Access Compliance Report

Public Rights-of-Way

Intersection ID: 42963	Main Street: RED_ROBIN_ST	Cross Street: PRAIRIEGROUSE_CT	Location: E
ADA ID: 143A0C5C4E3E	Ramp Type: PerpDiag	Initial Pass/Fail: Fail	Overall Compliance: No
Codes/Mitigation Info/Possible Solution		Field Measurements/Component Compliance	
Severity Score: 46.25

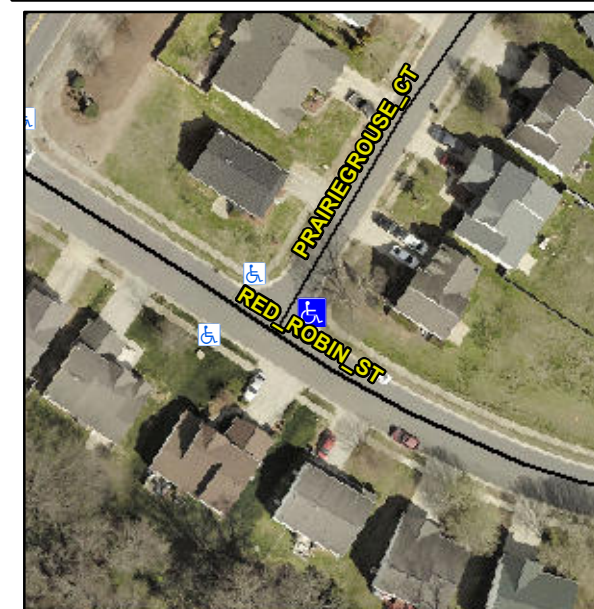
Not Found, R304.5.1, R304.2.2, R304.5.3

Compliance	Description	Data	Compliance	Description	Data
N/A	Ramp Length (in)	46.0	No	Ramp Slope (%)	8.4
No	Ramp Width (in)	46.0	No	Ramp XSlope (%)	15.0
N/A	Flare Type LT	N/A	N/A	Flare Type RT	N/A
N/A	Flare Slope LT (%)	N/A	N/A	Flare Slope RT (%)	N/A
N/A	Flare Traversable LT?	N/A	N/A	Flare Traversable RT?	N/A
N/A	Landing Length (in)	N/A	N/A	DWS Provided?	N/A
N/A	Landing Width (in)	N/A	N/A	DWS Contrast?	N/A
N/A	Landing Slope (%)	N/A	N/A	DWS Length (in)	N/A
N/A	Landing X Slope (%)	N/A	N/A	DWS Full Width?	N/A
N/A	Landing Curb? (Y/N)	N/A	N/A	DWS Offset (in)	N/A
N/A	Shared Landing?	N/A			
N/A	Gutter Ponding?	N/A	N/A	Gutter Slope (%)	N/A
N/A	Gutter Lip Ht (in)	N/A	N/A	Gutter X Slope (%)	N/A
N/A	Painted X Walk1?	No	N/A	Painted X Walk2?	No
	X Walk 1 Direction	To NW		X Walk 2 Direction	To SW
N/A	X Walk 1 Width (in)	N/A	N/A	X Walk 2 Width (in)	N/A
	X Walk 1 Slope (%)	8.4		X Walk 2 Slope (%)	2.2
	X Walk 1 X Slope (%)	1.9		X Walk 2 X Slope (%)	10.4

Remove & Replace Curb Ramp With Two New Directional Ramps or Equivalent.
